CITY of NOVI CITY COUNCIL

Agenda Item 5
May 21, 2018

SUBJECT: Consideration for tentative approval of the request of Cambridge of Novi, LLC, for Villa D'Este, JSP17-52, for a Planned Rezoning Overlay Concept Plan associated with a Zoning Map amendment 18.718, to rezone from RA (Residential Acreage) to R-1 (One-Family Residential). The subject property is approximately 51 acres and is located east of Napier Road on the north side of Nine Mile Road in Sections 29 and 30. The applicant is proposing a 42-unit single-family ranch housing development in a gated community.

OVERALL PLAN

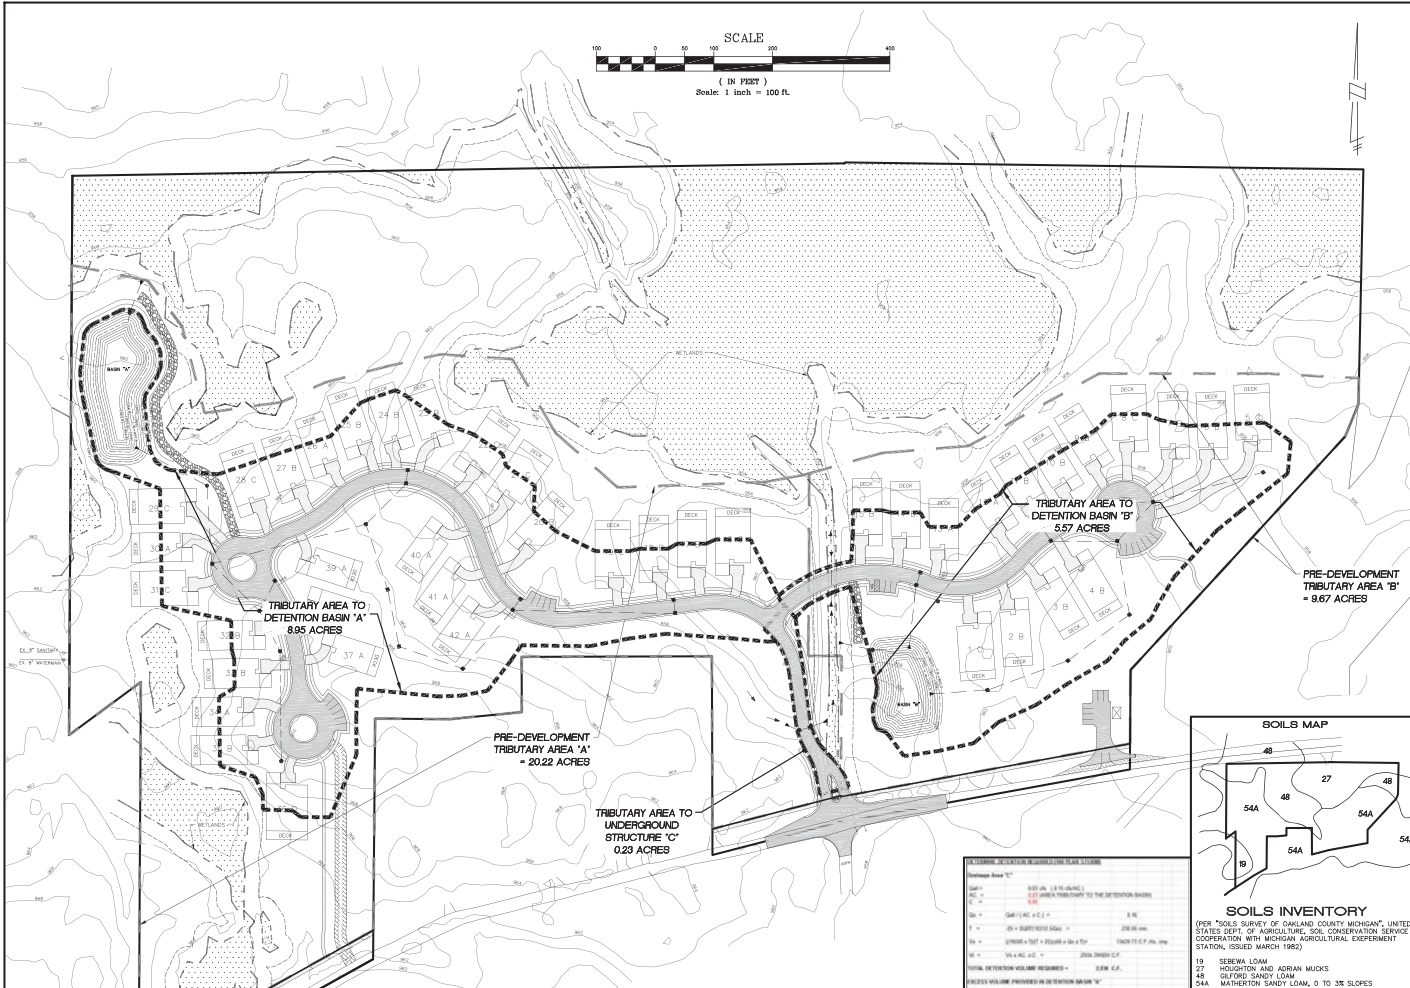
The following table summarizes the proposed wetland impacts as listed on the *Overall Plan* (Sheet 2):

It should be noted that the Wetland Impact table on the Plan indicates the impact area to the Wetland C buffer is 0.110-acre. The note in the plan view (i.e., Sheet 2) indicates the impact area as 0.01-acre. This quantity shall be clarified on the Plan.

sheet no.
LP-2

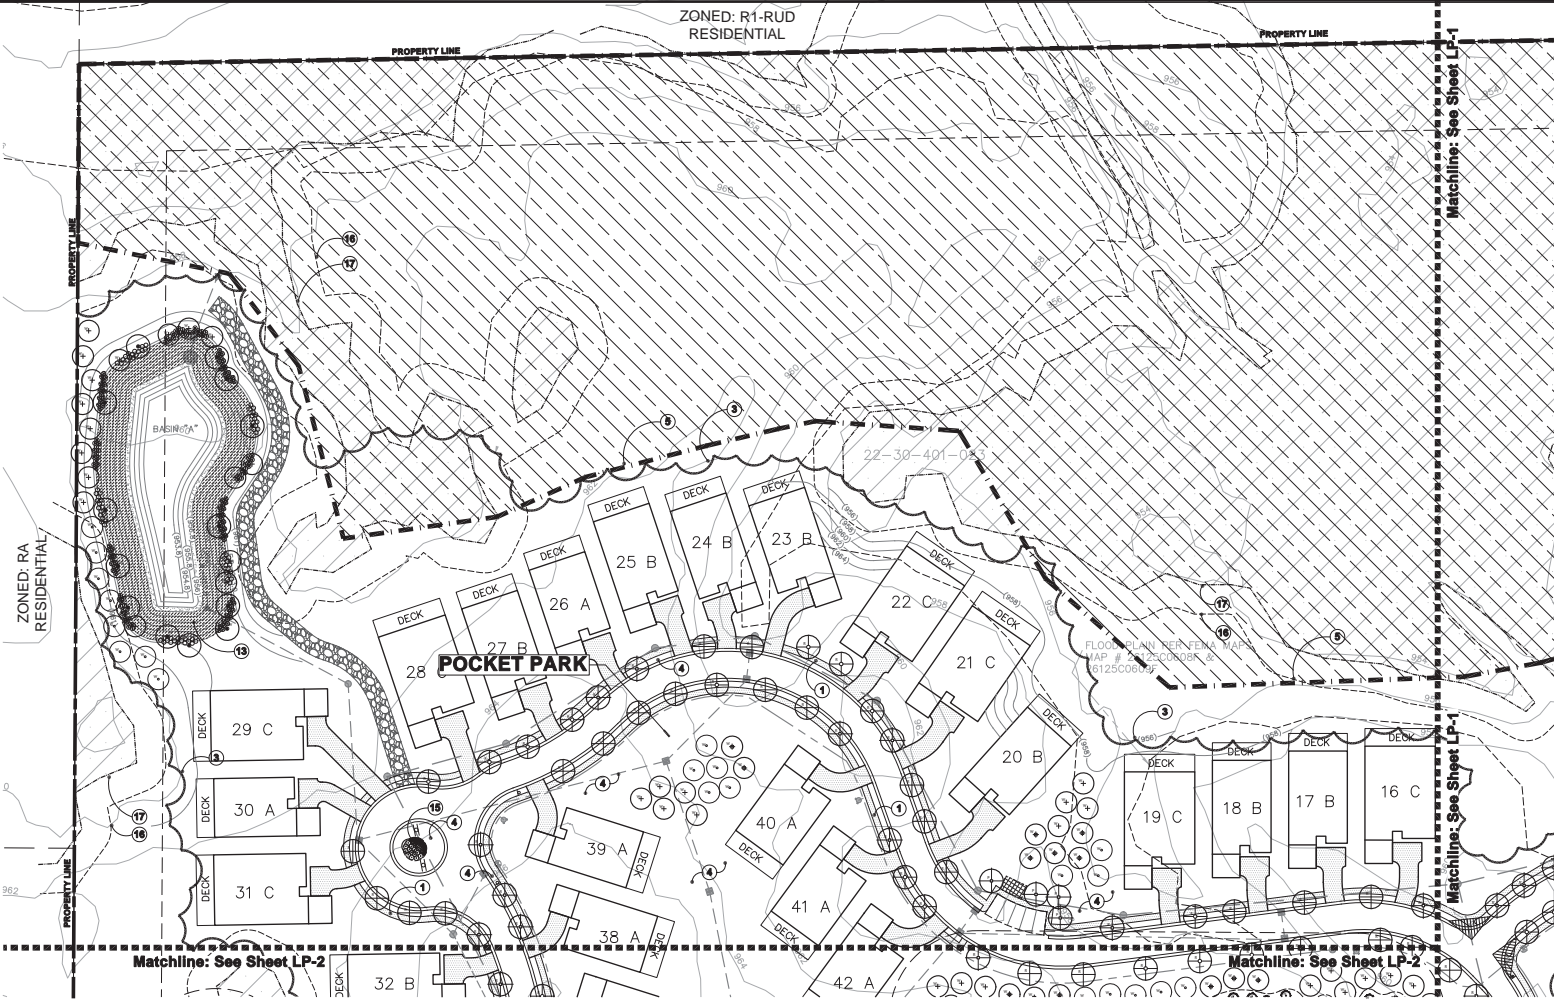
4. All proposed Woodland Replacement tree material shall meet the species requirements in the *Woodland Tree Replacement Chart* (attached). With regard to the Potential Replacement Trees Plant List on Sheet LP-2, two species of evergreen being proposed are not acceptable as Woodland Replacement Tree material:
 - a. Concolor fir (*Abies concolor*); and
 - b. Green spruce (*Picea pungens*).

sheet no.
 WP-1

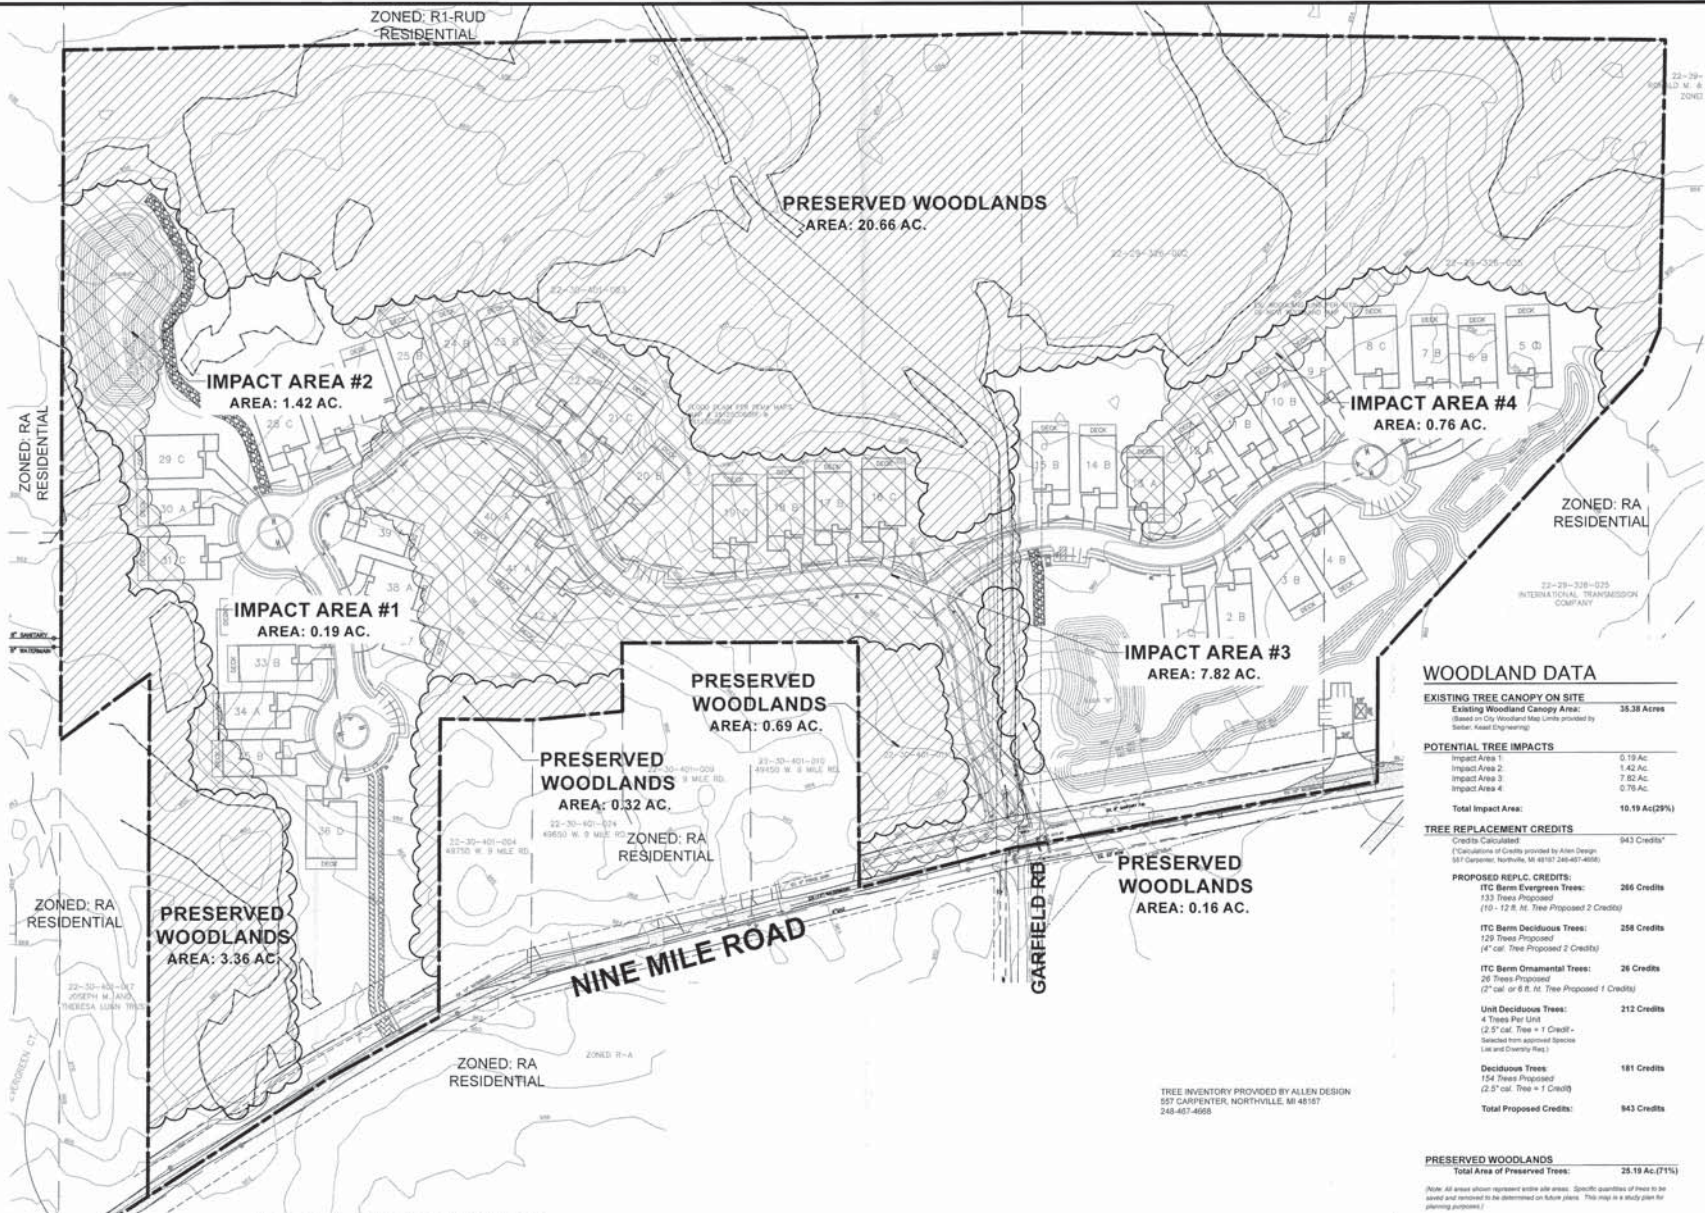
Sheet WP-1 (Woodland Study Plan) notes that a total of 943 Woodland Replacement Credits are required and that 943 Woodland Replacement trees will be replaced on-site through the planting of Woodland Replacement materials. Again, the Woodland Consultant has determined that, after correcting for the upsizing of the proposed replacement trees on the ITC Berm, there is a shortage of 307 credits being replanted on the site, due to upsizing.

Sheet WP-1 (*Woodland Study Plan*) notes that a total of **943** Woodland Replacement Credits are required and that **943** Woodland Replacement trees will be replaced on-site through the planting of the following Woodland Replacement materials. It should be noted that the applicant is requesting additional Woodland Replacement Credit for the upsizing of replacement tree material. This is not supported by the City's Woodland Ordinance for Woodland Replacement Trees:

5. Specific to Sheet WP-1 (Woodland Study Plan), the Woodland Replacement Credits should be revised accordingly:
 - a. ITC Berm Evergreen Trees – Evergreen trees shall be counted at a replacement ratio of 1.5 trees to 1 credit;

- e. Deciduous Trees – A total of 179 (non-berm) deciduous trees appear to be indicated on Sheets LP-1 through LP-3, however 181 credits are listed in the Tree Replacement Credit information on Sheet WP-1. This shall be revised.

This comment still applies. The Woodland Study Plan (Sheet WP-1) notes that part of the 882 Woodland Replacement Credits provided are proposed through the planting of 10' to 12' tall evergreen trees at 2 credits per tree and 4" caliper deciduous trees at 2 credits per tree along the existing ITC corridor. Again, the "upsizing" of Woodland Replacement trees for additional Woodland Replacement credit is not supported by the City of Novi.
